Addendum 128 – Regulation No. 129

Amendment 6

Uniform provisions concerning the approval of Enhanced Child Restraint Systems (ECRS)

Figure 1

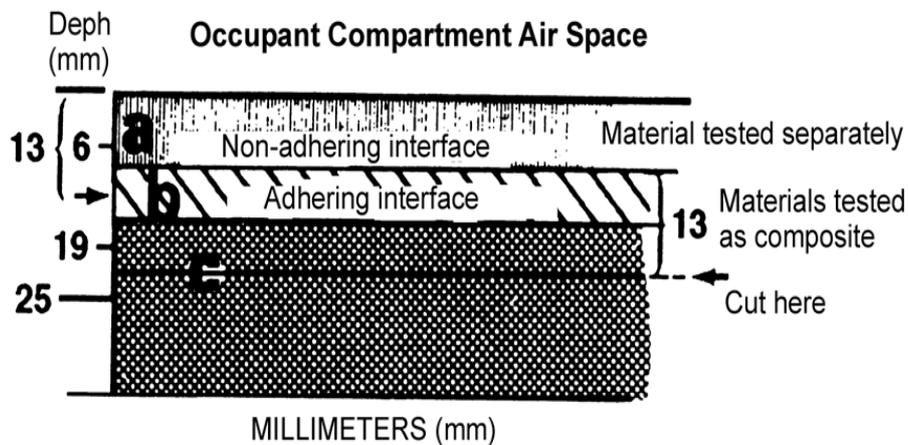
Insert a new Annex 23, to read:

1. Definitions
"Occupant compartment air space" means the space within the occupant compartment that normally contains refreshable air.
2. Material selection (see Figure 1 below)
 - 2.1. Any portion of a single or composite material which is within 13 mm of the occupant compartment air space shall meet the requirements in paragraph 6.1.6.

- 2.1.1. Any material that does not adhere to other material(s) at every point of contact shall meet the requirements of paragraph 6.1.6. when tested separately
- 2.1.2. Any material that adheres to other materials at every point of contact shall meet the requirements of paragraph 6.1.6. when tested as a composite with the other material(s).
- Material A has a non-adhering interface with material B and is tested separately.
- Part of material B is within 13 mm of the occupant compartment air space, and materials B and C adhere at every point of contact; therefore, B and C are tested as a composite.
- The cut is in material C as shown in Figure 1, to make a specimen 13 mm thick.
